#### Report to the Future Melbourne (Planning) Committee

Ministerial Planning Referral: TPM-2018-23 28-38 Pearl River Road and 3-43 Waterfront Way, Docklands 15 October 2019

# DELEGATE REPORT MINISTERIAL PLANNING REFERRAL

Outline Development Plan 3-43 Waterfront

Figure 11 - East-west section depicting proposed maximum building heights

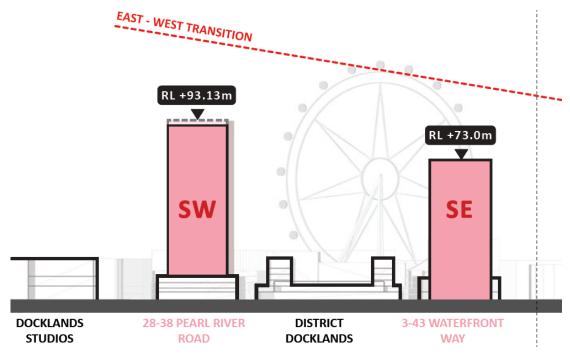
As illustrated in the extracts from the WFCDP and proposed addendum, the application seeks to increase the permissible height of the two development sites from 25 metres to 90.95 and 70.82 metres respectively; accounting for a ground level RL of +2.18 metres.

Figure 13 - East-west section depicting originally proposed maximum building heights

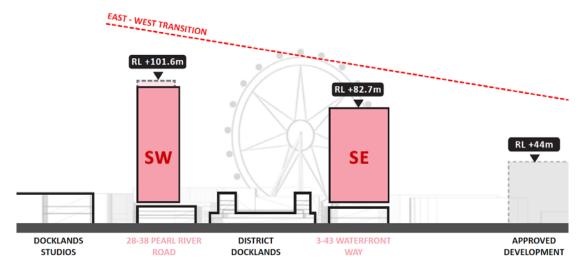
It is pertinent to note that the maximum heights of the abovementioned building envelopes have been reduced from the originally proposed heights of 99.2 and 80.3 metres (refer to Figure 13).

Figure 17 - Extract of the endorsed Level 14 plan, highlighting the street boundary (from Drawing TP211)

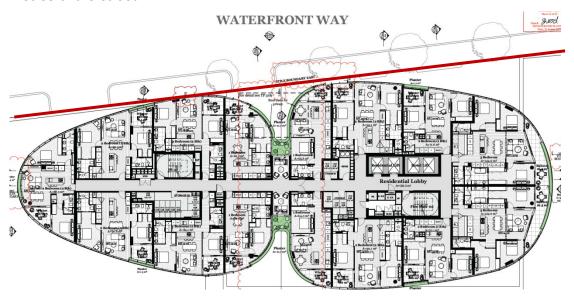
In terms of the reduced setback for the south-east site, this is necessary to accommodate the tower that is already under construction. As illustrated in the extract below, the combined apartment building / residential hotel has a curved façade, which at one point is built to the Waterfront Way street frontage. With a setback of up to seven metres, the bulk of the approved development is within five metres of the street.

Given the circumstances, it is unfeasible to mandate a five metre setback to a building that is currently under construction.

Figure 18 - 3D render of proposed development, showing additional proposed height in red

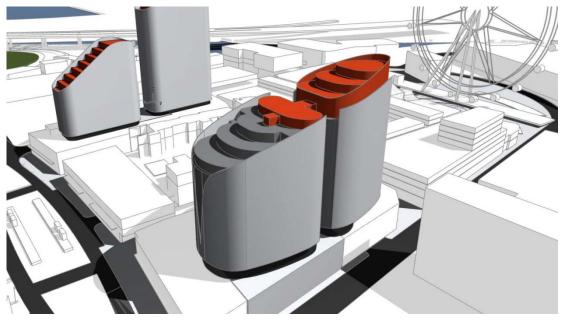
The proposed addendum would add an additional 12.63 metres, or 3-4 storeys on top of this building. This additional height has been modelled by the applicant and an extract is reproduced in Figure 18 on the following page.

Figure 19 - Equinox shadow diagrams, showing shadows at 1pm (left) and 3pm (right)

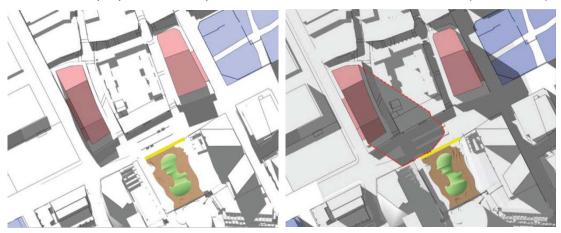
This overshadowing constraint has shaped the proposed building envelopes, which slope from north to south. In order to protect the abovementioned spaces, the Development Plan Addendum includes a control mandating that no part of NewQuay Central Park or the footpath on its northern side receive any additional shadows on the equinox between 11am and 3pm. The submitted overshadowing diagrams, based on the proposed envelopes, demonstrate that this is achievable (refer below).

Figure 20 - Proposed building envelopes and indicative massing of NewQuay West from the top of the wheel

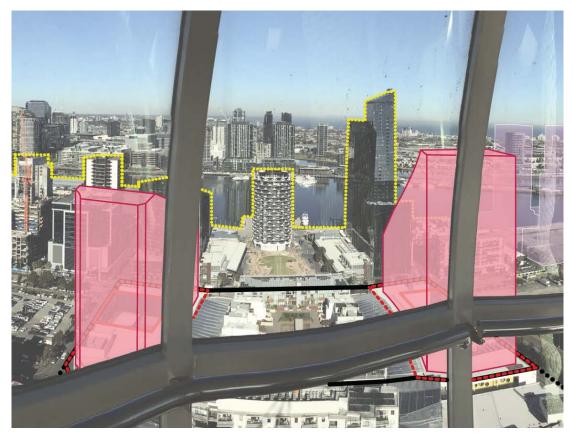
To demonstrate the impact of the proposal on views from The Wheel, the applicant has superimposed the building envelopes on a photo of Victoria Harbour and Port Phillip Bay taken as the pod reaches the top of The Wheel. This graphic is reproduced below.

Although the proposal would reduce some views from The Wheel, it is nevertheless considered that important views from the Wheel are adequately protected by virtue of:

Figure 21 - 3D model depicting proposed building envelopes from Victoria Harbour Promenade

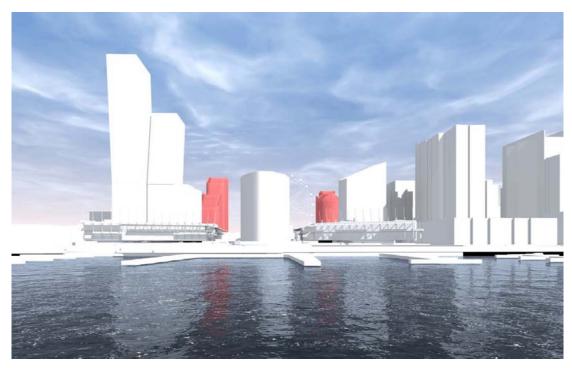
In terms of views from Victoria Harbour, the building envelopes would be most visible from Victoria Harbour Promenade, near the City of Melbourne Library at The Dock. The extent of visibility is depicted in the 3D model at Figure 21 on the following page:

Noting that both sites already have approvals for tall buildings, it is considered that the larger buildings permitted by the Development Plan Addendum would:
